BOSTON REGION METROPOLITAN PLANNING ORGANIZATION

DATE April 3, 2014
TO Boston Region Metropolitan Planning Organization (MPO)
FROM William Kuttner, MPO Staff
RE A Preferential Lane on I-93 North: A Conceptual Plan

Comment Letter from I-93/I-95 Interchange Consulting Engineers

Date: March 5, 2014
To: Ed Hollingshead
From: Rick Azzalina
Re: A Preferential Lane on I-93 North: A Conceptual Plan
FST Review Comments

FIGURE 2
Proposed Sections of I-93 North
Preferential Lane System

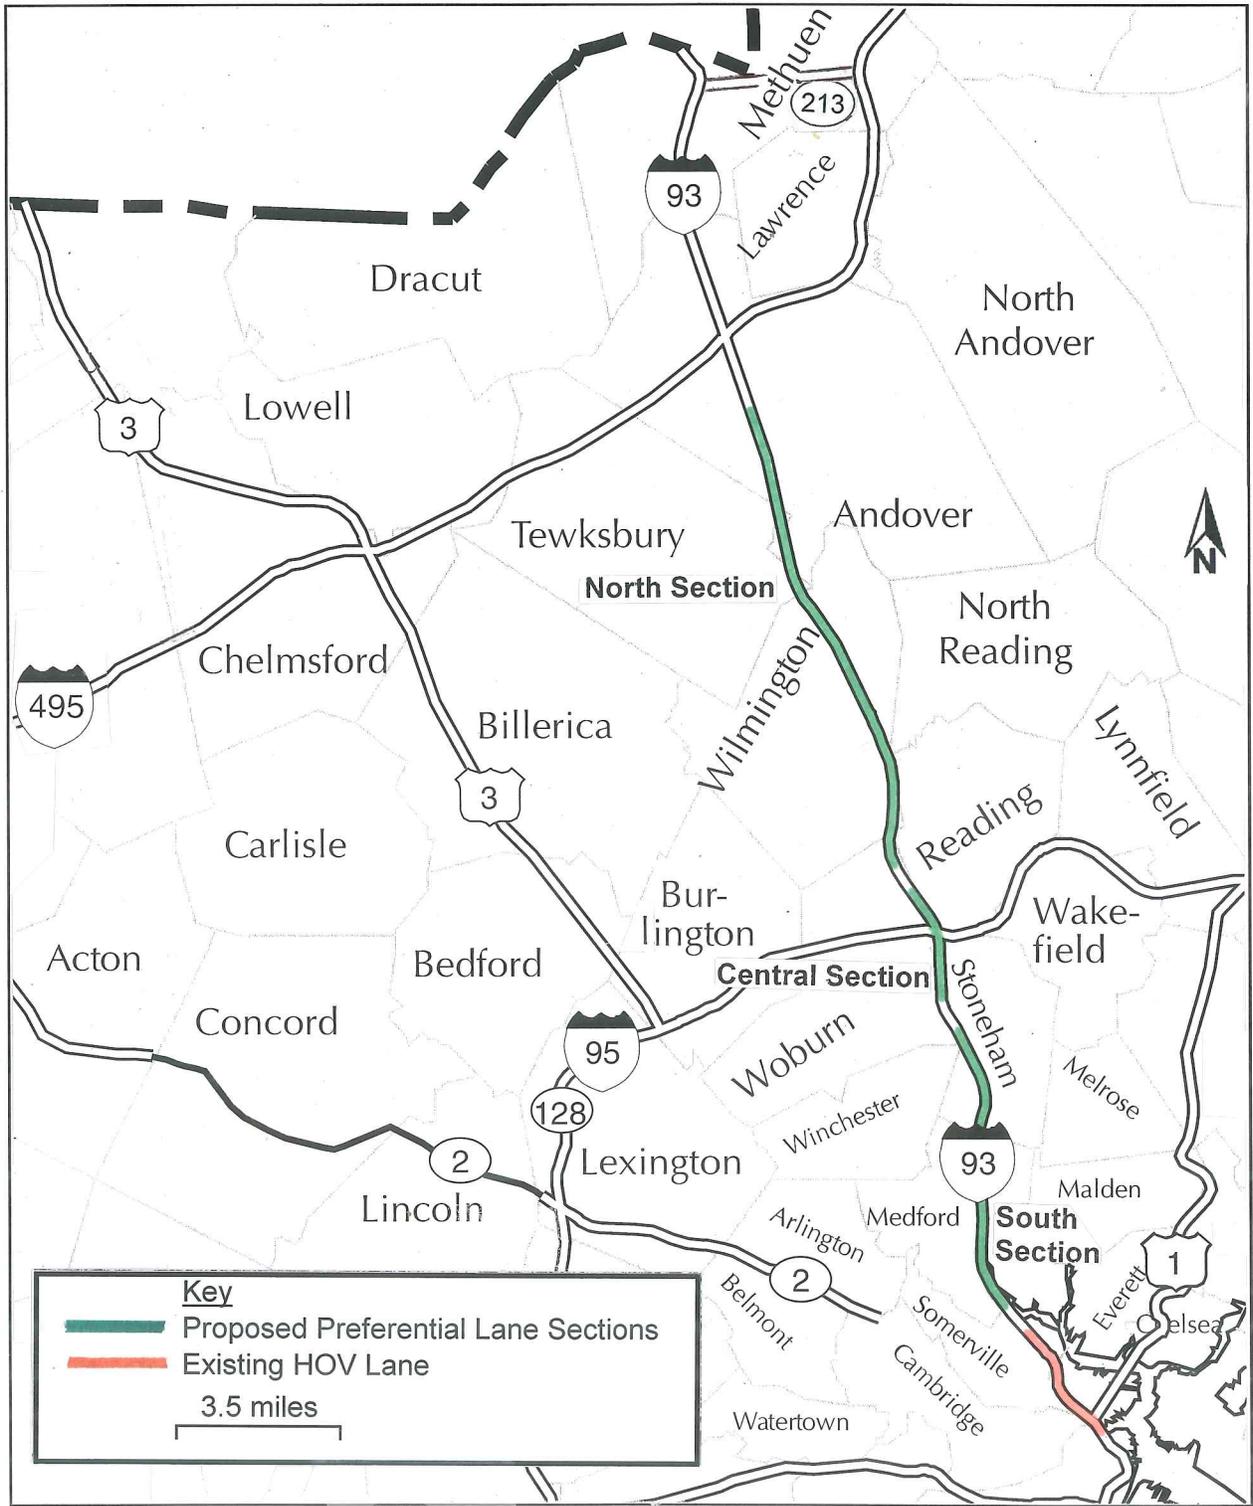
1. On Page 3 a statement reads *“The Phase II Study focuses on I-93 north of Boston, and proposes a system that would function as an extension of the existing north-side HOV facility, as shown in Figure 2.”* This terminology is confusing. The existing HOV facility is a southbound HOV facility from approximately the Medford/Somerville line to the Charles River Crossing. *[This text has been modified.]*
2. The Introduction and Background sections of the memorandum provide the reader with a brief but comprehensive history of the HOV lane, and its various extensions, north of Boston. This historical information is quite helpful and provides a basis for the current recommendations.

FIGURE 3
Southbound: Existing and Proposed Lanes, Ramps, and Reversible Preferential Lane

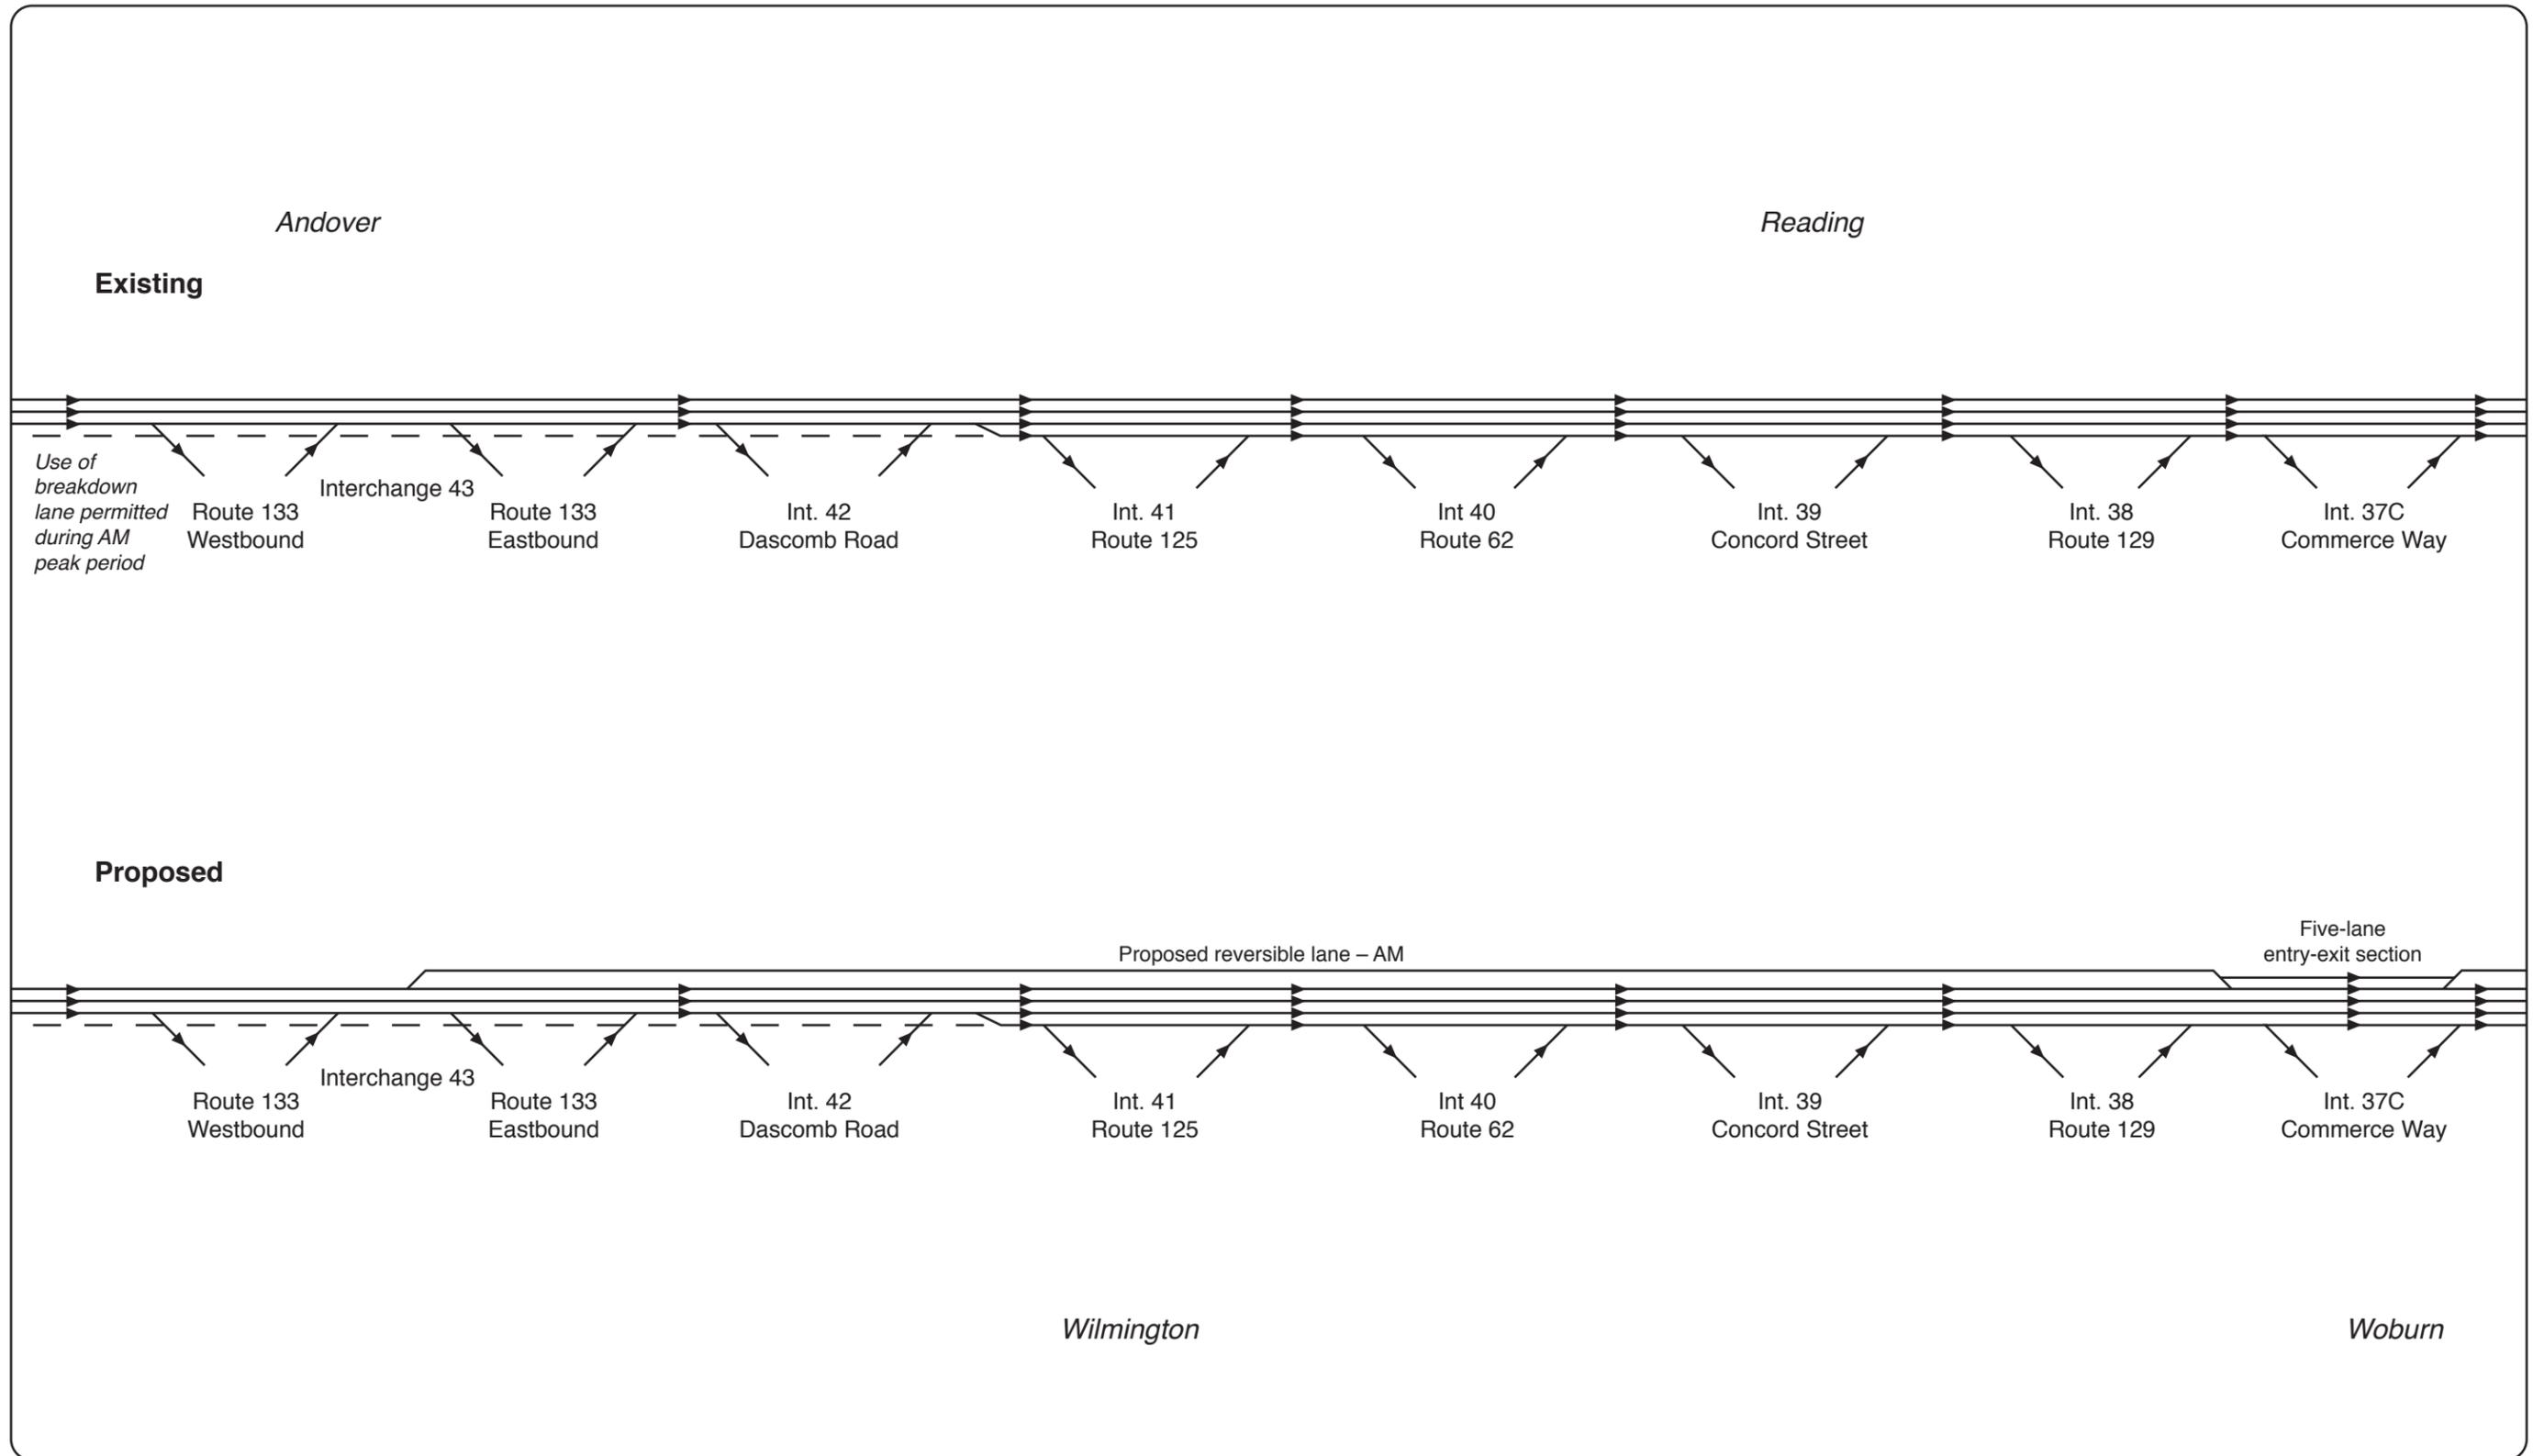
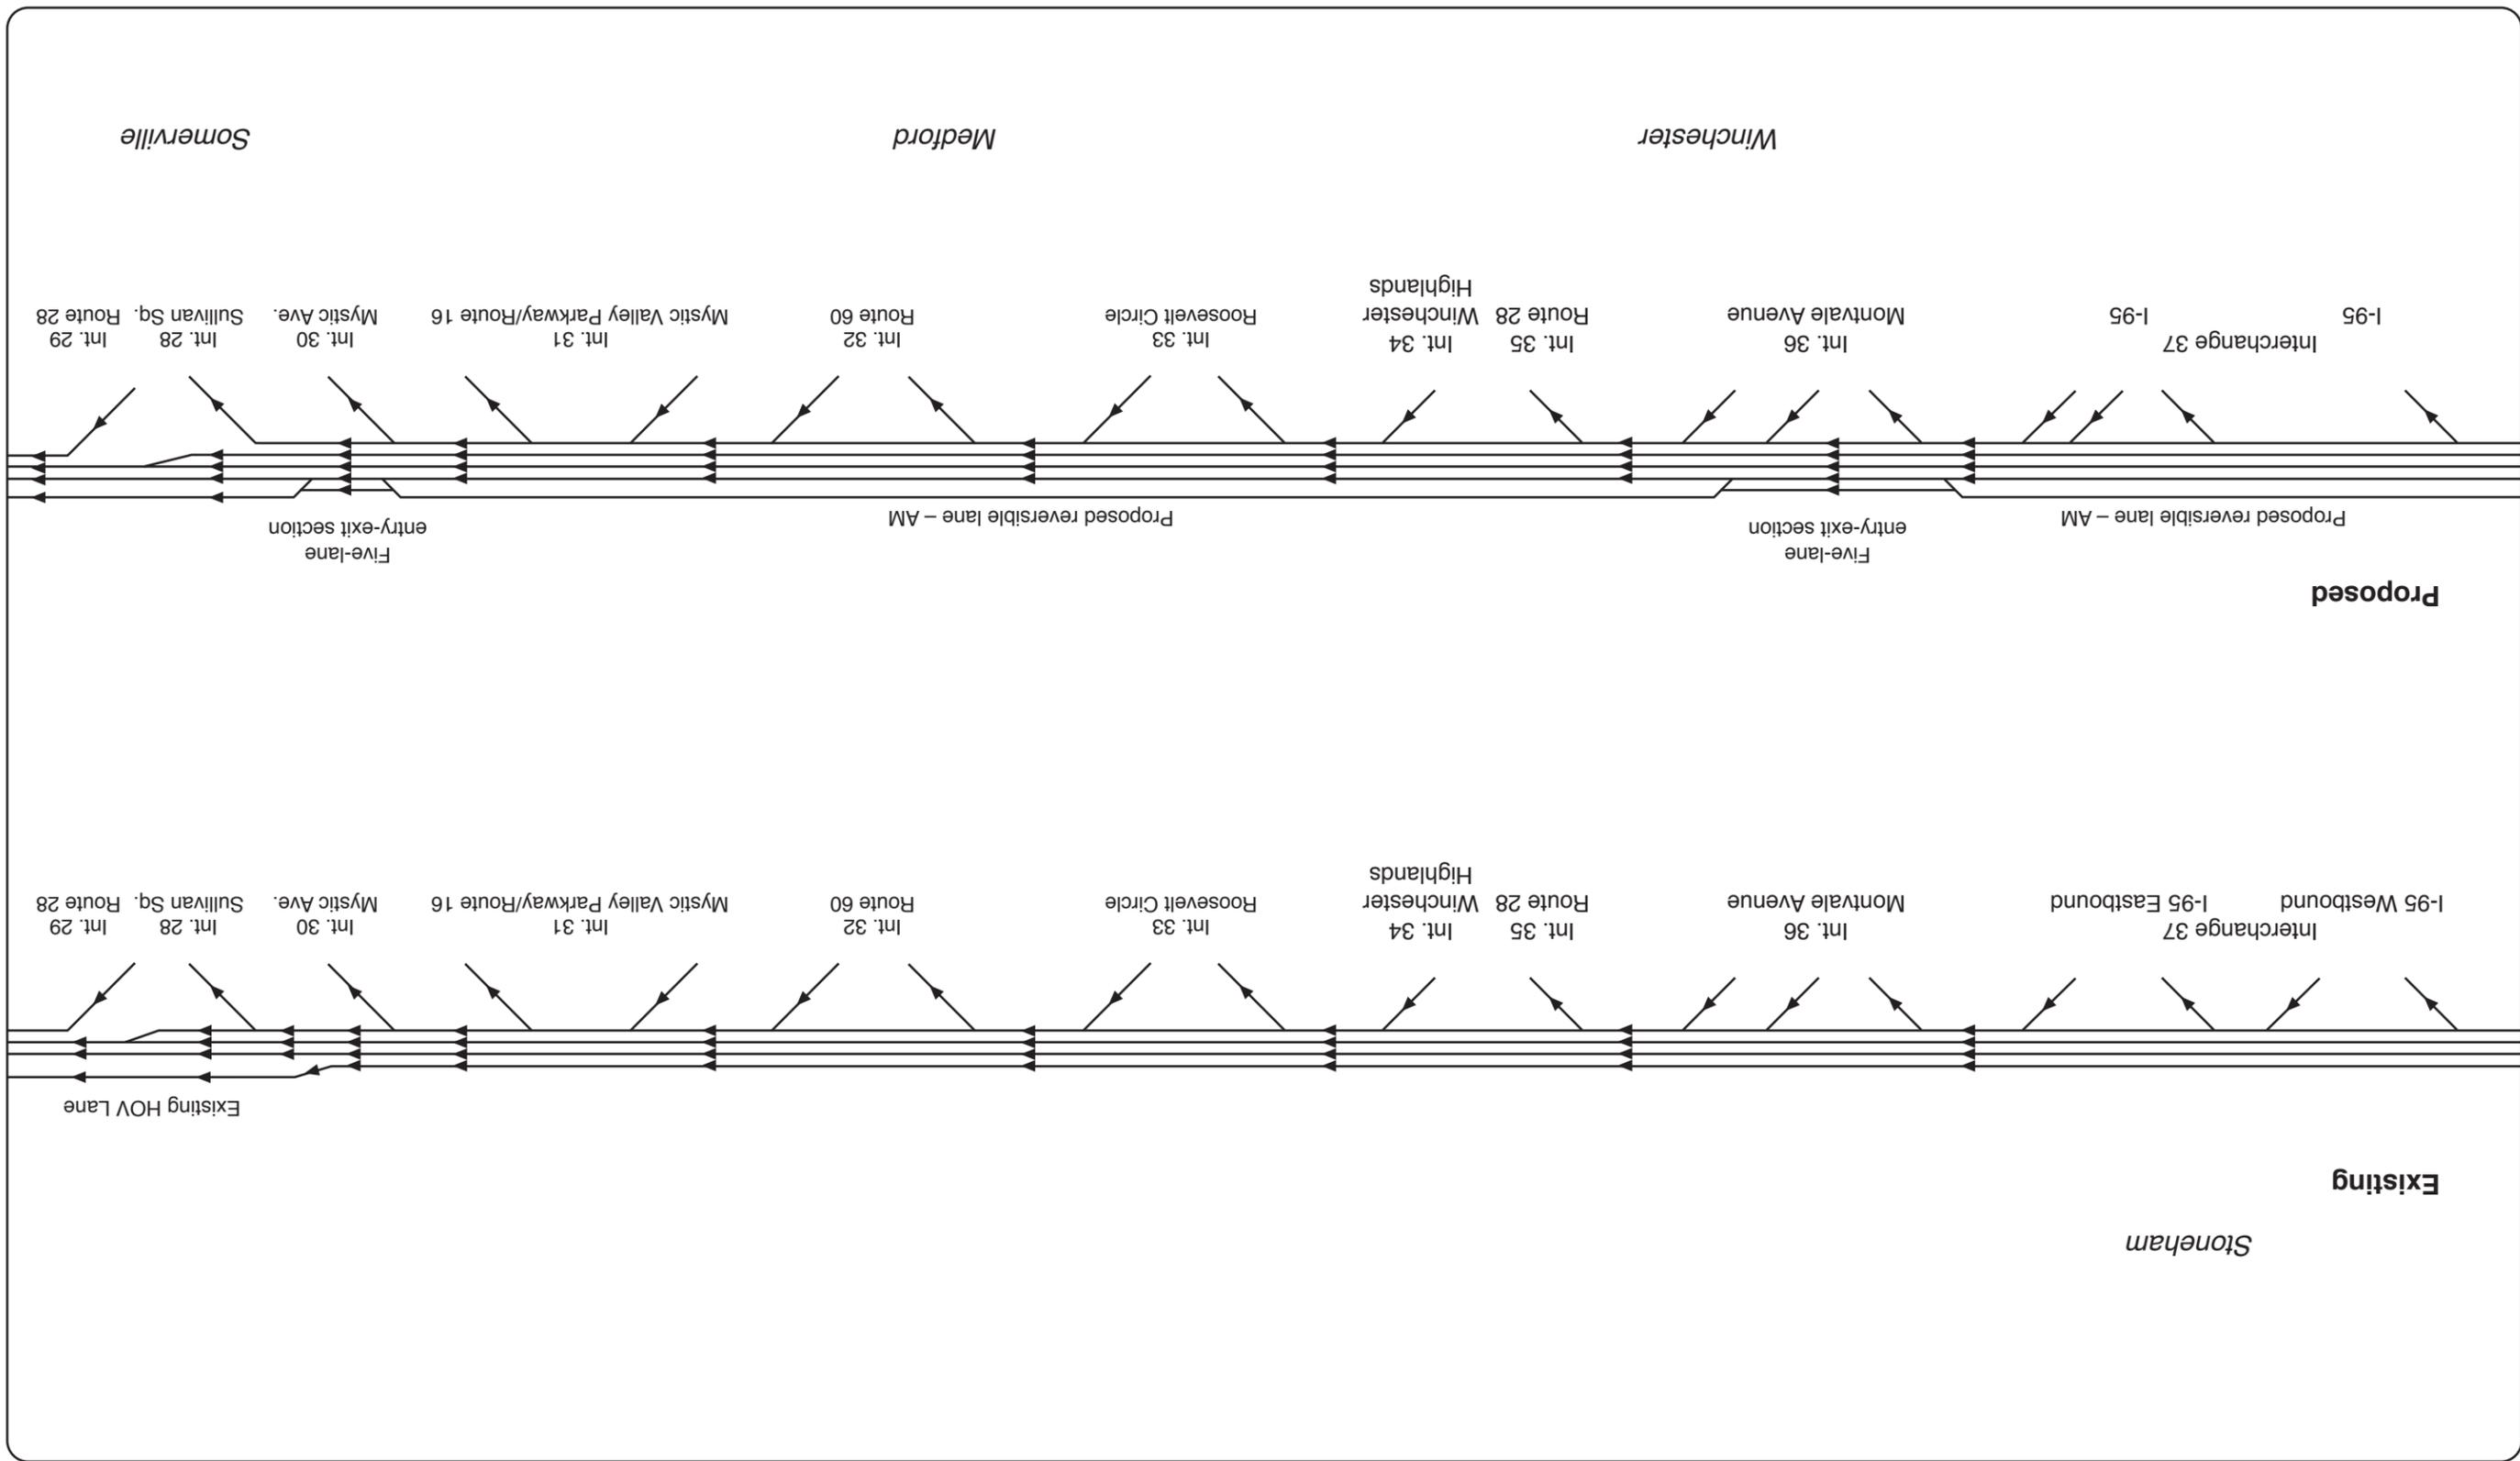
9. On Page 12, regarding the proposed northern terminus of the southbound preferential lane system is states "*The entrance of the reversible lane is shown in Figure 3 as positioned among the cloverleaf ramps of Interchange 43. The entrance would be south of the Route 133 viaduct that crosses I-93, thereby eliminating any need to reconstruct this viaduct.*" Based on Figure 3 and the above language, it appears the entry point is located between the I-93 southbound on ramp from Route 133 and the I-93 southbound off ramp to Route 133 East. An entry at this location would be problematic because of the proximity of the Route 133 clover leaf on ramp to I-93 southbound and the potential for undesirable weaving patterns. For I-93 southbound traffic an approximate taper distance of 1000 feet is required to achieve the necessary 26 foot shift and enter the preferential lane in the median. For these reasons, it is recommended the entry point (i.e., start of physical barrier separation) be shifted further north just north of the I-93 southbound on ramp from Route 133 and as far south as possible from I-495.

12. The five-lane entry-exit section at Interchange 36 (Montvale Avenue) appears to be located where problematic weaves could result. The limits this reversible, entry-exit section appears to be different on Figure 3 from that shown on Figure 4. We suggest moving this 1,500 section further north such that the physical separation between the preferential lane and general purpose traffic ends just north of the I-93 southbound on ramp from Montvale Avenue westbound. The terminals for the existing I-93 southbound off ramp to Montvale Avenue and the existing I-93 northbound on ramp from Montvale Avenue should be extended northerly to physically prohibit traffic connections between the reversible, preferential lane and Interchange 36. Modification of these ramp terminals should not be a problem since these ramps are connected to extended auxiliary lanes.

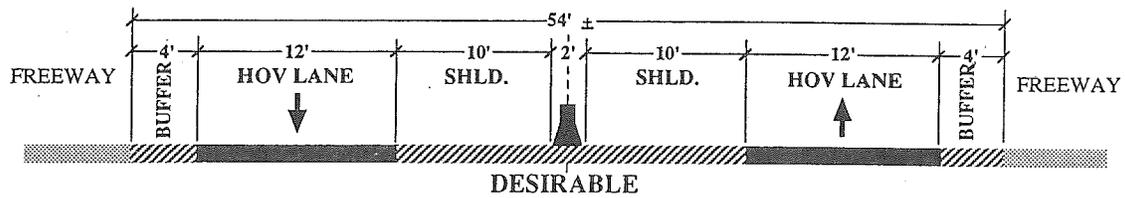
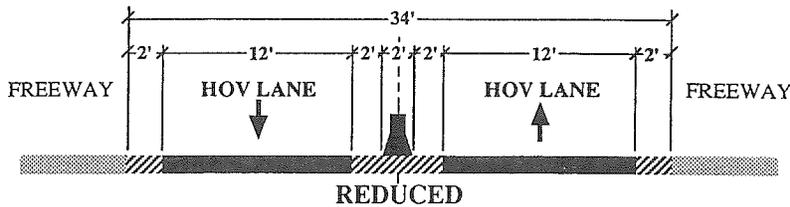
- The recommended reversible lane width is 28 feet. Pavement markings shown on Figure 6 on Page 37 indicate use of a 12 foot shoulder, 12 foot reversible lane and 4 foot shoulder.
